***MODIFICATION REQUEST:
Wollongong Hospital Redevelopment
Crown Street, Wollongong
MP 10_0213 MOD 1***

***Construction of a multi-level car park to
support Wollongong Hospital Redevelopment***

Director-General's
Environmental Assessment Report
Section 75W of the
Environmental Planning and Assessment Act 1979

Figure 4: Proposed car park entry / exit points

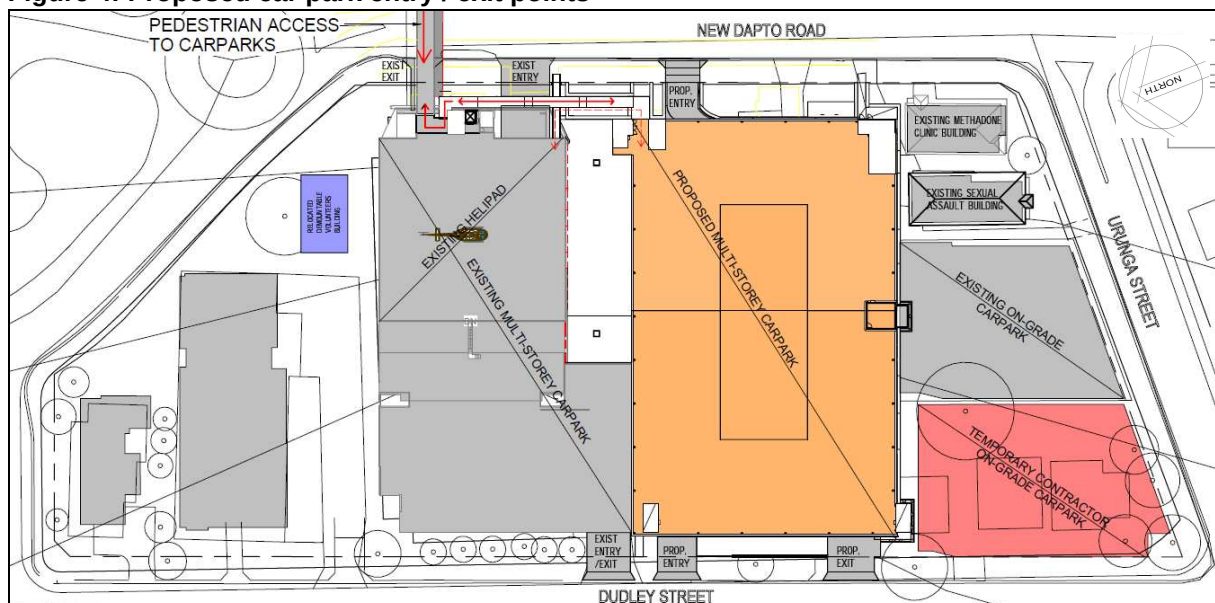
Council and Transport for NSW have queried whether all vehicle access points are required given the potential for pedestrian/vehicle conflict due to the numerous vehicle crossovers.

- even though the car park is designed so that it operates as a single car park, with connections on all levels to the existing car park, the two car parks may operate as standalone car parks to separate staff and visitor parking; and
- the fewer the number of access points, the greater the potential for adverse traffic impacts through additional vehicle queuing.

The department has reviewed the number of vehicle access points and notes that the primary access to the hospital will be via the pedestrian link and therefore pedestrian activity is unlikely to traverse the numerous vehicle access points. The vehicle access points along Dudley Street are similar to those that are currently provided and where there were two vehicle cross over points on New Dapto Road where the cottages are located, there will now be a single cross over. This new vehicle access point would result in a greater number of traffic movements compared to that of the two previous cross overs, however, this access is required to accommodate vehicle queuing requirements on New Dapto Road. Furthermore, due to the locations of the bus stops and station, the vehicle access points would not result in any additional conflict points with public transport users' access to the campus. Accordingly, the department considers the proposed access points acceptable.

Figure 6: Photomontage view of the car park along New Dapto Road with views to the escarpment in the background

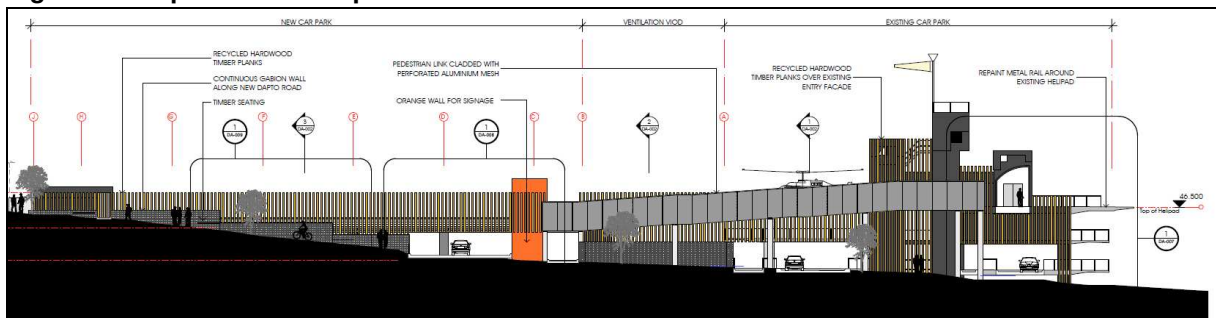
The six level car park will generally be situated below ground level along the New Dapto Road frontage due to the slope of the site, and will only appear as a single level structure. Timber planks are proposed along the façade to soften the building edge and this treatment is extended along the entire New Dapto Road frontage of the existing car park (see **Figure 5** and **6**). The department considers the treatment will improve the appearance of the existing car park and also integrate the two car parks visually as well as functionally.

The proposed car park would have minimal view impacts on the views to the west of the mountains from east of the car park as the car park only presents as a predominantly single level development to New Dapto Road and the hospital is situated higher up the slope (see **Figure 6**). Any views from the hospital would be generally unaffected and any views from beyond the hospital would be already impacted by the hospital buildings on the main campus. As the site falls away to the north-west and the proposed scale of the car park is consistent with the existing car park, views impacts on the surrounding area would be minimal as they would either already be lost as a result of the existing car park or the view point would be on higher ground and above the uppermost level of the car park. The department considers the view impacts are minor and satisfactory.

Figure 8: Southern (Urunga Parade) Elevation

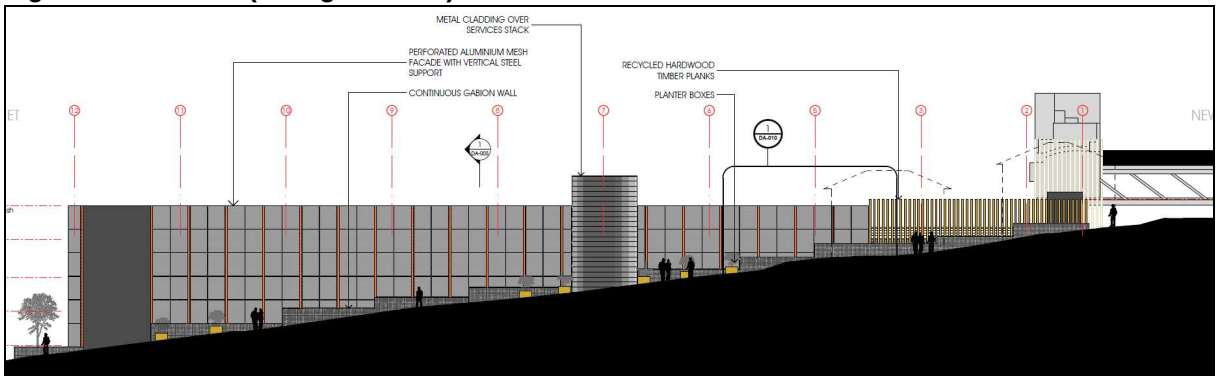
The car park will mainly be visible from Dudley Street and Urunga Parade (see **Figure 7** and **8**), but would be screened from Sperry and Mercury Street by the existing car park. The proponent has adopted a similar treatment as that used for the existing car park with perforated aluminium mesh along both the two highly visible facades, which screens the car parking functions whilst still allowing for passive surveillance.

The car park will align with the existing hospital car park and would be visually prominent along Dudley Street given its scale and minimal setback. The car park would be less intrusive from Urunga Parade as it is situated down the slope, largely below street level, and setback from the campus boundary. The proponent has proposed orange colouring on the vertical steel supports to activate the façades. Orange is also utilised on the signage wall on New Dapto Road and signage panels along Dudley Street to provide visual connectivity with the hospital redevelopment, which uses an orange colour palette in the façade treatment. The department considers these elements will provide visual interest and improve the appearance of the car park.

The department considers the façade treatment is acceptable and will provide visual interest. The incorporation of the orange will help break up the monotony and the blank appearance of the elevations. Furthermore, due to the fall of the subject site and excavation proposed to align the new car park with the levels of the existing car park, which is situated on lower ground, the car park would only be approximately two levels taller than the existing engineering workshop building being demolished. It is also generally consistent with the existing larger scale form of the buildings on the hospital campus and the potential future form within the area surrounding the hospital given the strategic vision of establishing a medical precinct around the hospital, as evidenced by the 32 metre height limits around the hospital campus.
